STAFF RECOMMENDATION

1411 Boscobel Street

February 17, 2016

Application: Demolition—principle building; New construction—infill

Figure 2 (left) is the 1951 Sanborn Map, and Figure 3 (right) is the 1957 Sanborn Map. 1411 Boscobel appears on the 1957 map, but not on the 1951 map.

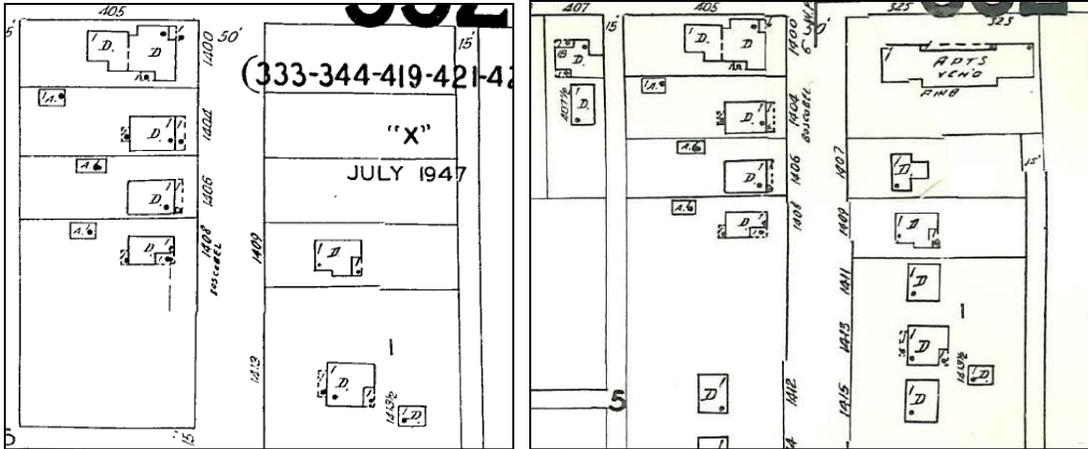
Demolition: 1411 Boscobel Street was constructed between 1951 and 1957, as it does not appear on the 1951 Sanborn map but does on the 1957 Sanborn Map (Figures 2 & 3). This is outside the period of historic significance for the Lockeland Springs neighborhood. The house's materials include smooth concrete block foundation and vinyl siding, which are not typical of historic houses in Lockeland Springs. The house lacks details common in historic Lockeland Springs houses, like eave overhangs and porches. Staff finds that existing house does not contribute to the historic character of the Lockeland Springs-East End Neighborhood Conservation Zoning Overlay. Staff therefore finds that its demolition meets Section III.B.2 for appropriate demolition and does not meet section III.B.1 for inappropriate demolition.

SITE PLAN				
HPR LOT 172 BLK Q				
LINDSLEY HOME				
1411 BOSCOBEL ST				
NASHVILLE, TN 37206				
PREPARED FOR: MIKE MATHEWS				
DATE	SCALE	SHEET	DRAWNBY	PROJECT
JAN 25, 2016	1" = 30'	1 OF 1	DME	16009

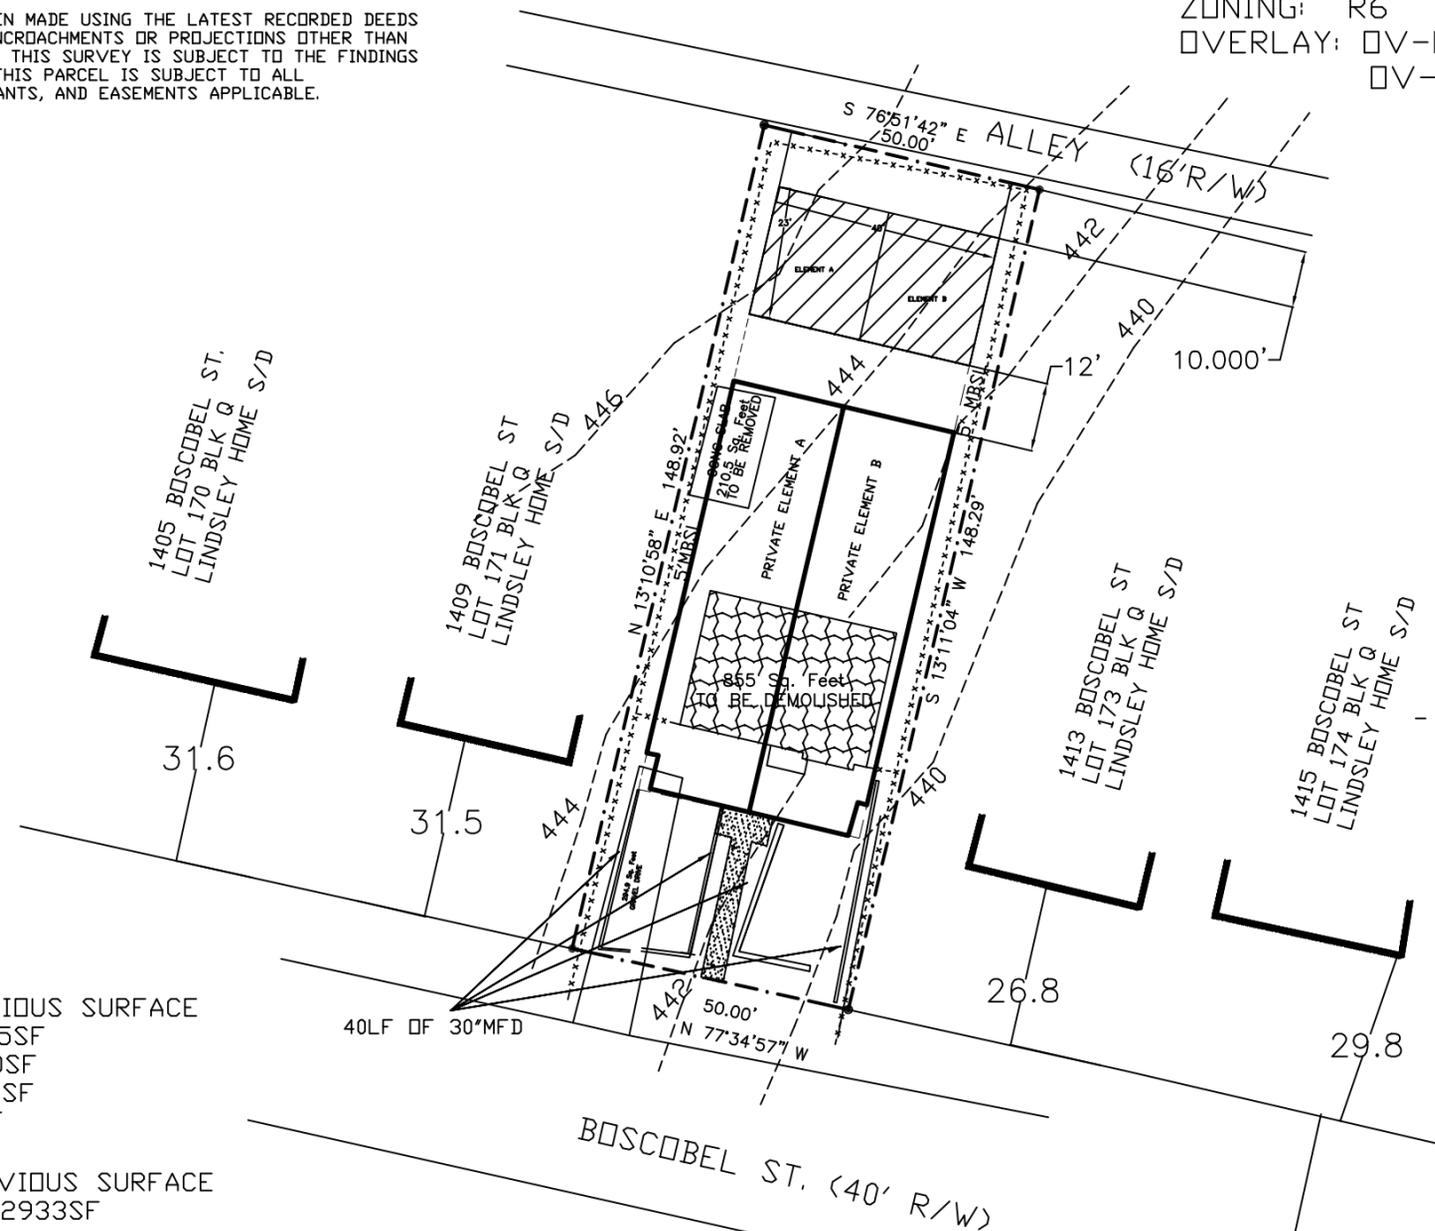
Appurtenances & Utilities: The location of the HVAC and other utilities was also not noted. Staff asks that the HVAC be located on the rear façade, or on a side façade beyond the midpoint of the house. The front yard will include modified French drains. Staff recommends that the existing gravel driveway be removed.

UNIT-A FIRST FLOOR PLAN UNIT-B
 SCALE: 1/8"=1'-0"

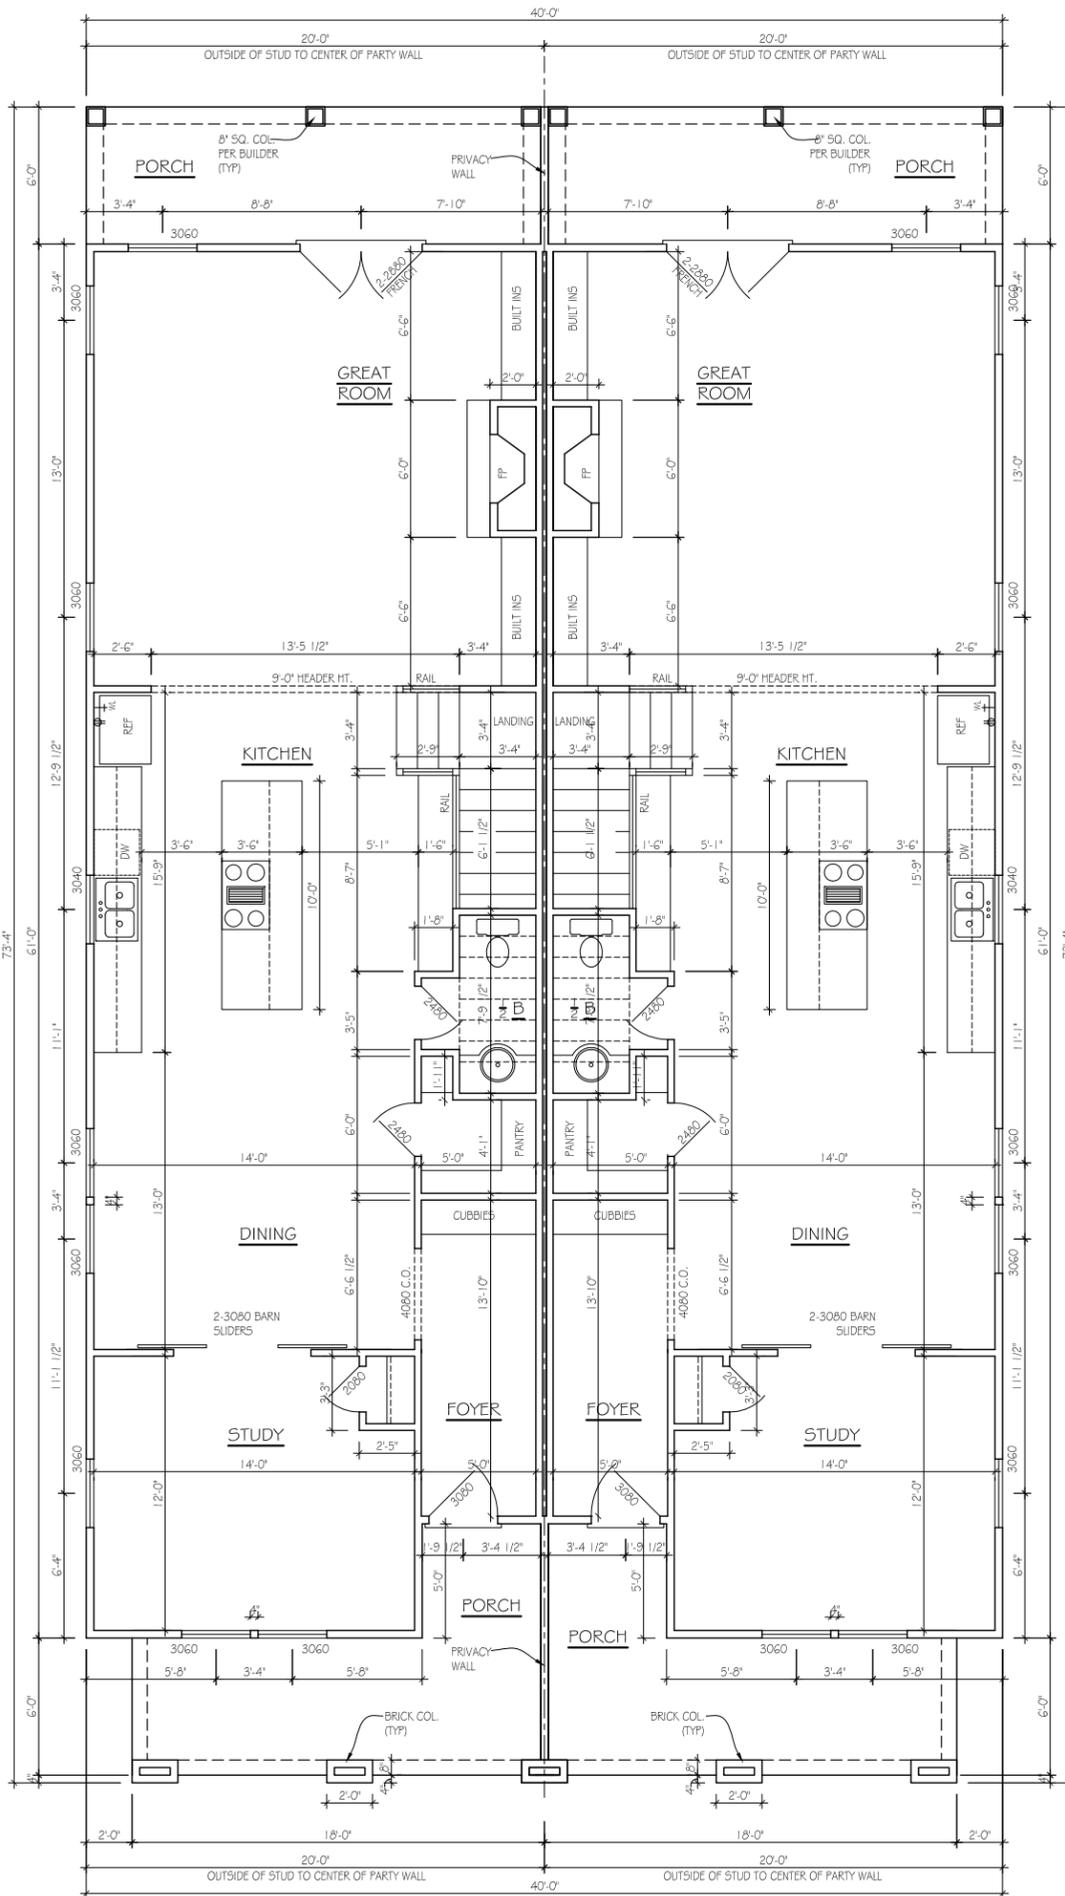
Orientation: The new infill will be a duplex, with two front entries facing Boscobel Street. The entries will be located behind a six foot (6') deep front porch, and will be recessed an additional five feet (5') from the front wall of the house. The plans show a wall dividing the porch to separate the two units, and staff recommends that the wall be removed in the area of the porch (although it may remain in the recessed area). A front walkway will be added from Boscobel Street to the front porch. Vehicular access to the site will be at the rear, via the alley, to two parking pads. There are no outbuildings proposed under this application. Staff finds that the project's orientation meets Section II.B.1.f. of the design guidelines.
